**Addendum No. 001**

**Subject: 2020 Classroom Modernizations**  
**SDP Contract Numbers: B-028 C of 19/20 & B-030 C of 19/20**

**Location: Overbrook Educational Center**  
**6722 Lansdowne Ave, Philadelphia PA 19151**

**This Addendum, dated March 6, 2020, shall modify and become part of the Contract Documents for the work of this project. Any items not mentioned herein, or affected by, shall be performed strictly in accordance with the original documents.**

DRAWING NO.  
**ED1.1**

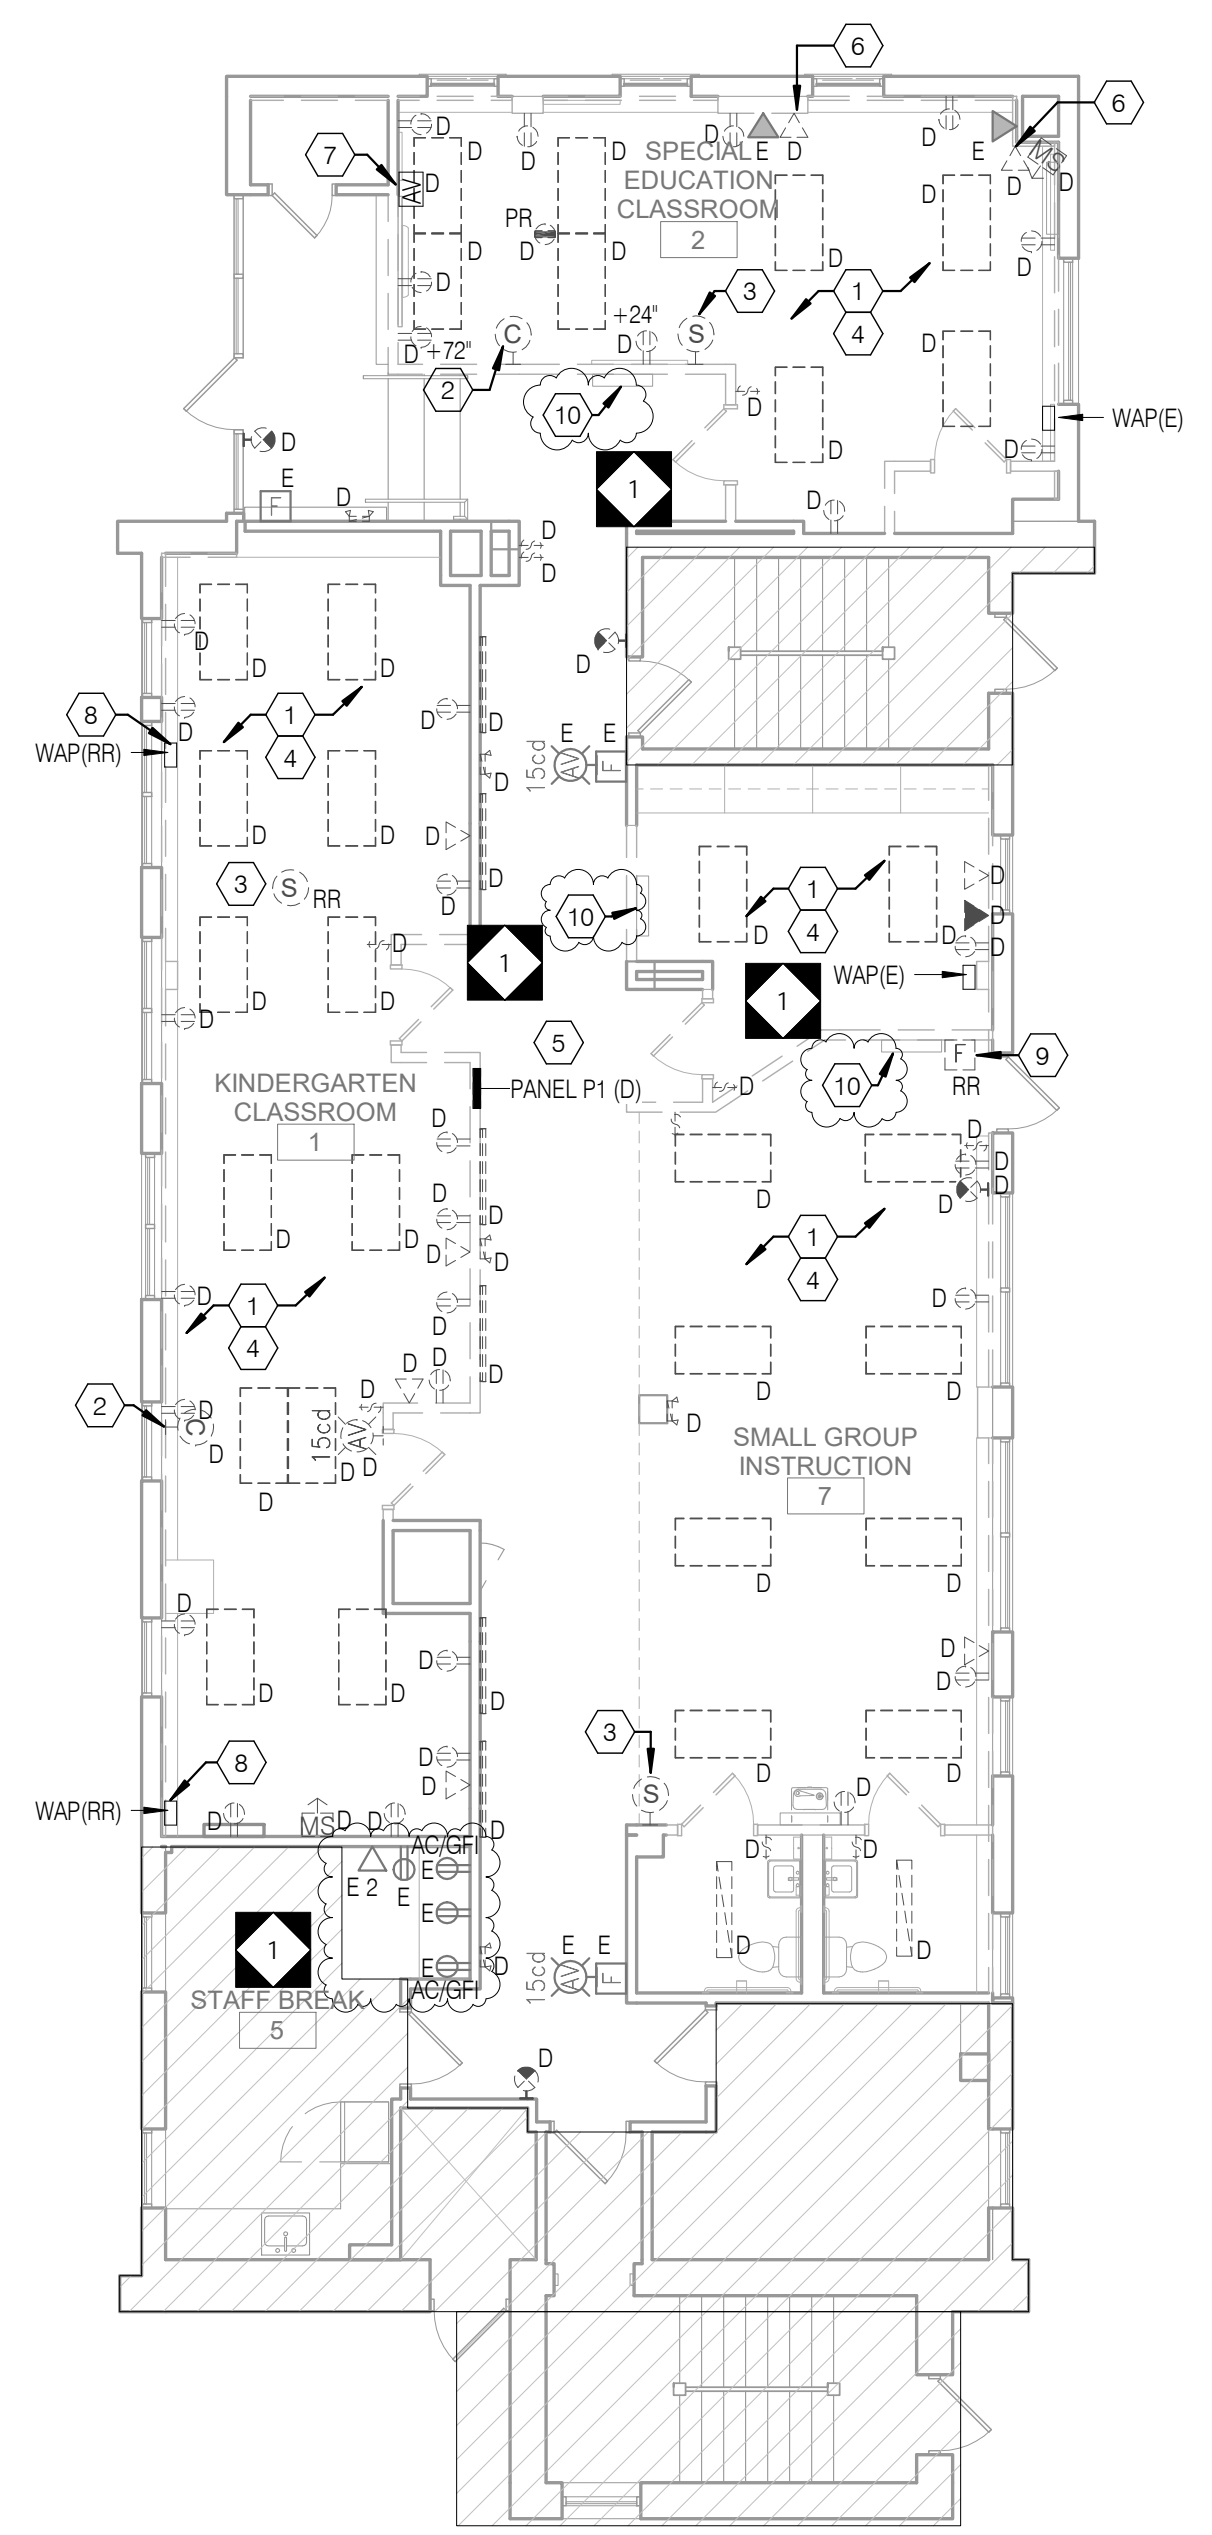
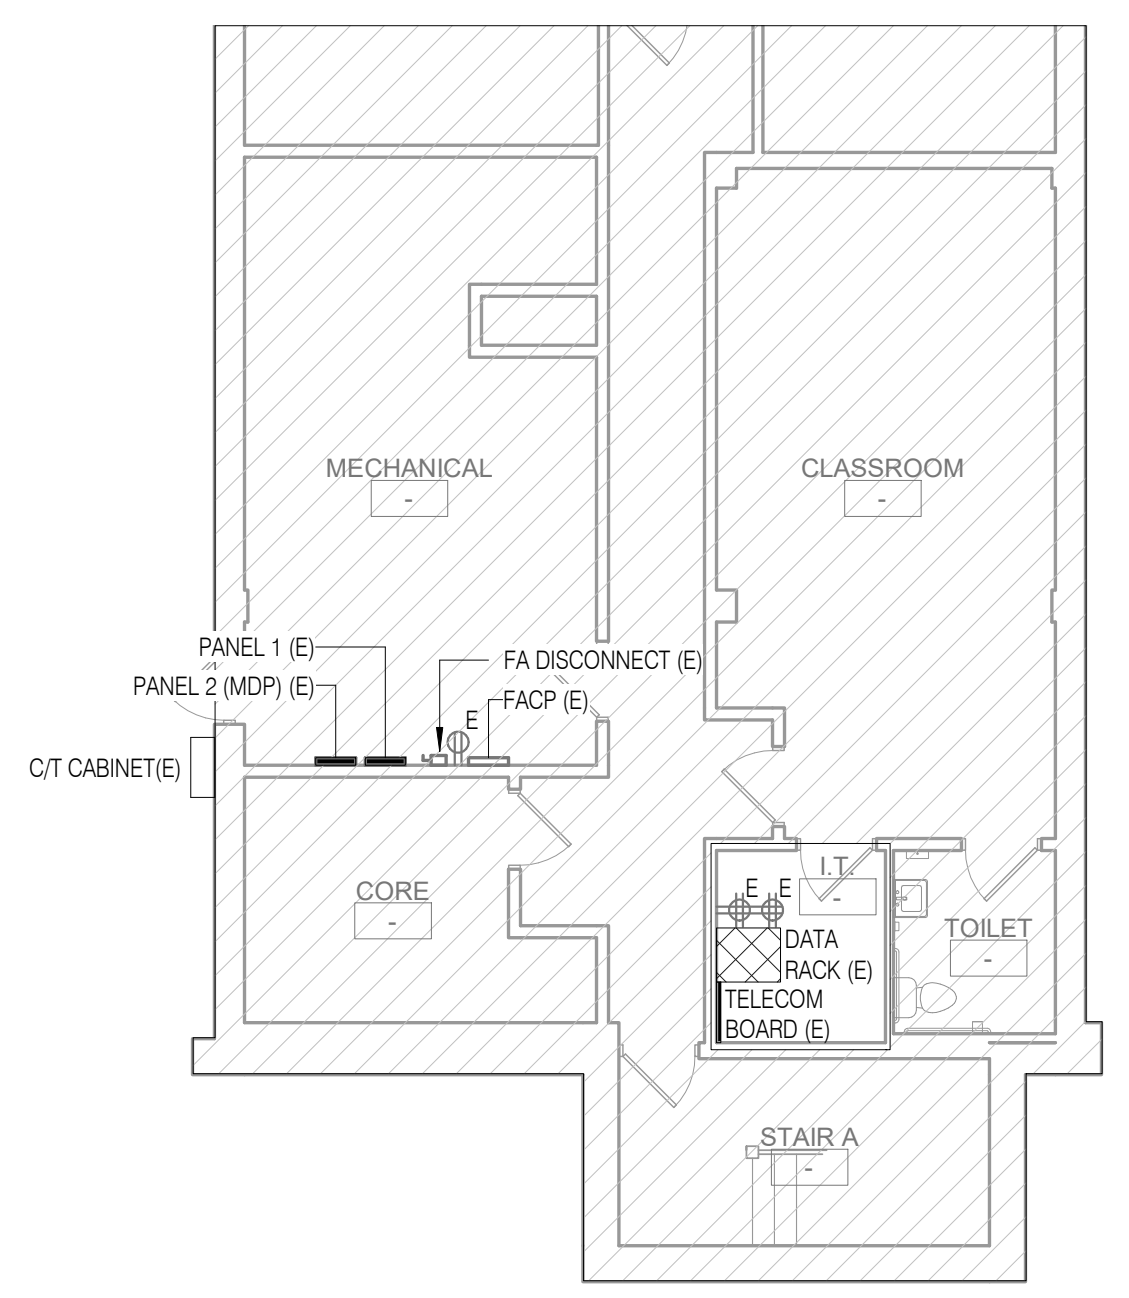
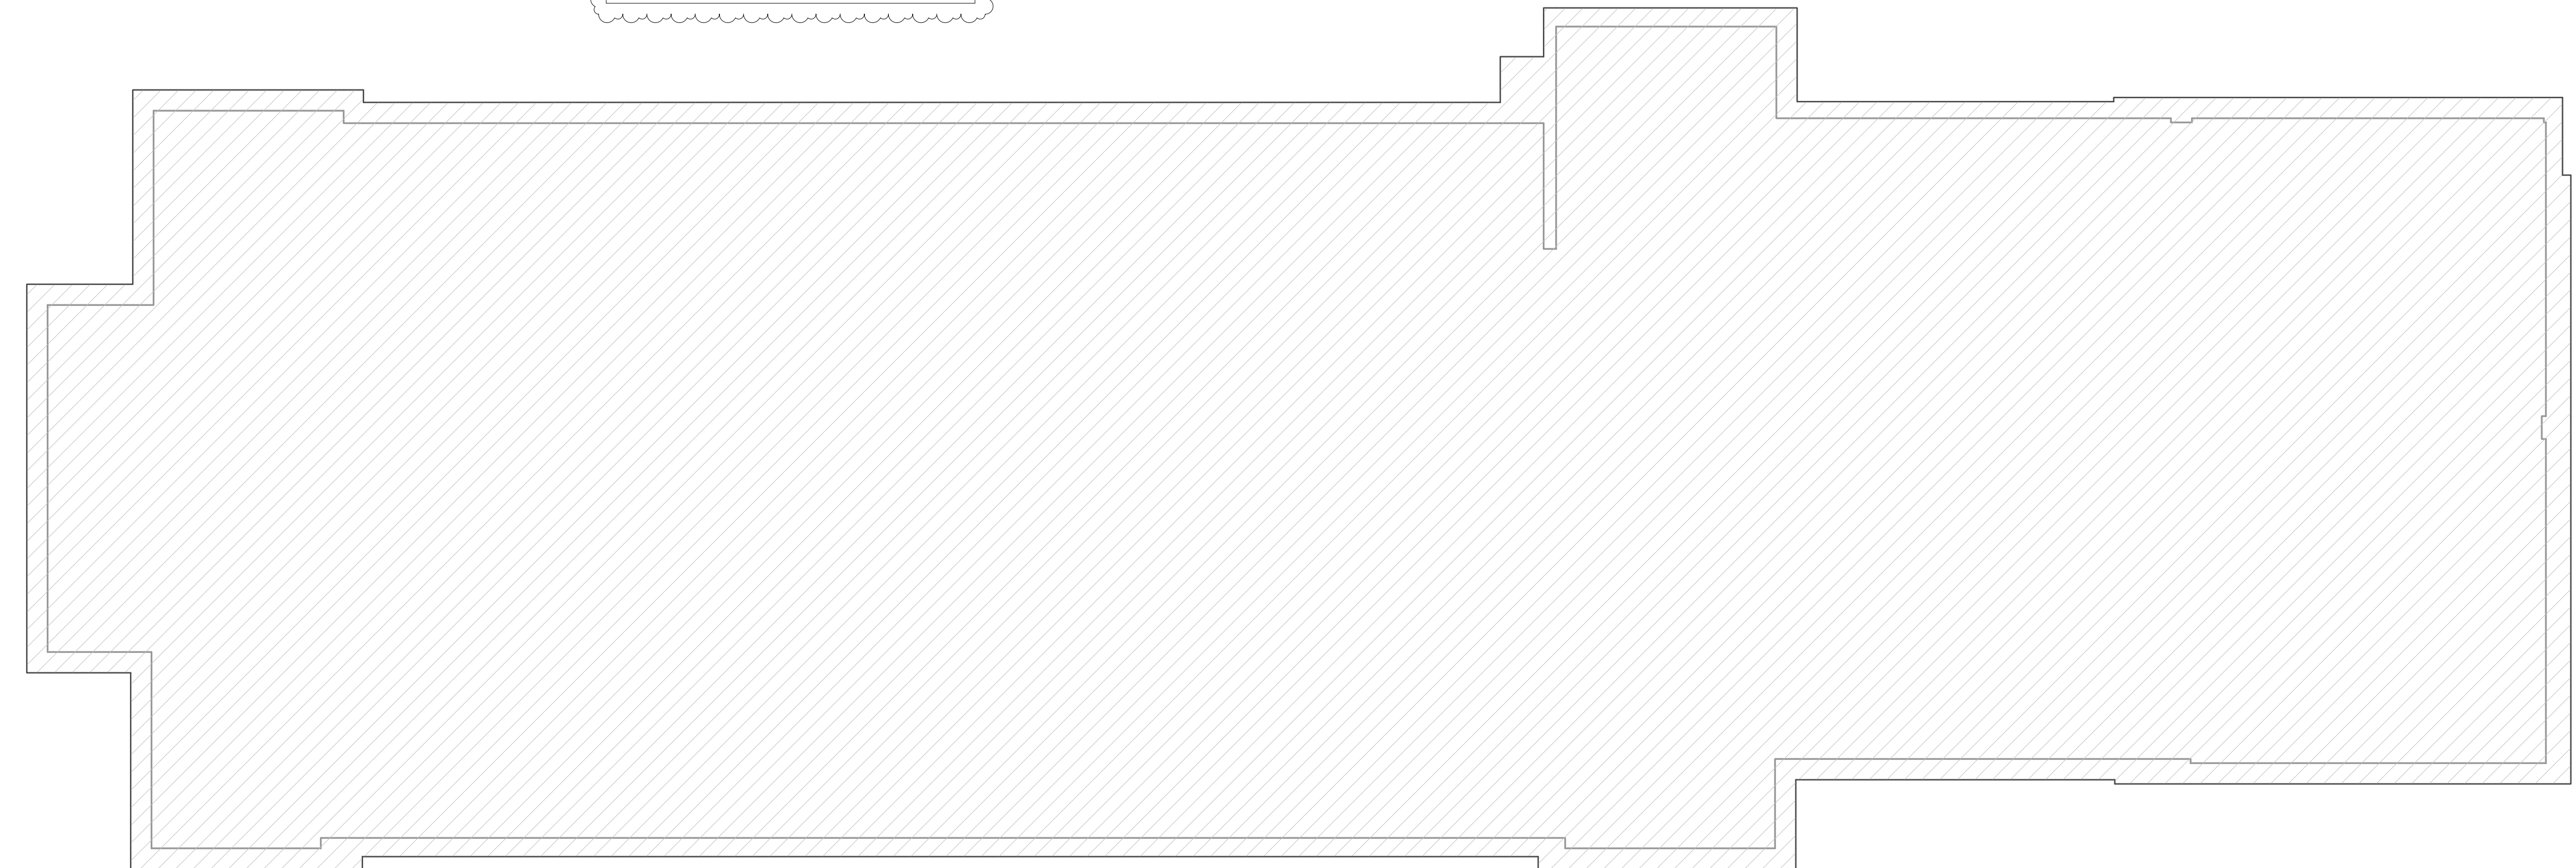
1. ADD Keyed Note #10 to read “DISCONNECT AND REMOVE EXISTING MECHANICAL EQUIPMENT AND ASSOCIATED CONTROLS, CONDIT AND WIRING BACK TO SOURCE OF SUPPLY. REFER TO PLUMBING DRAWINGS AND ARCHITECTURAL DRAWINGS FOR ADDITIONAL INFORMATION.”

2. CLARIFY general note in larger font to read "ELECTRICAL CONTRACTOR TO PROVIDE ALLOWANCE FOR REMOVAL OF 10'-0" OF SURFACE MOUNTED RACEWAY/ CONDUIT AND CONDUCTORS IN EACH CLASSROOM."
3. ADD existing to remain receptacles in Staff Break #5.
